REMARKS**Allowable Subject Matter**

IN THE DRAWINGS:

FIG. 4

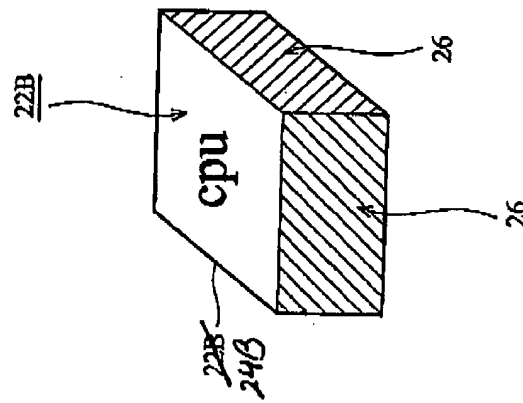
FIG. 4 has been amended by replacing the label "22B" on the left side with "24B". Support for the amendment is shown on page 5, lines 20-22 in the specification, "the isolation substrates 20A and 20B are cut along cutting lines 24A and 24B".
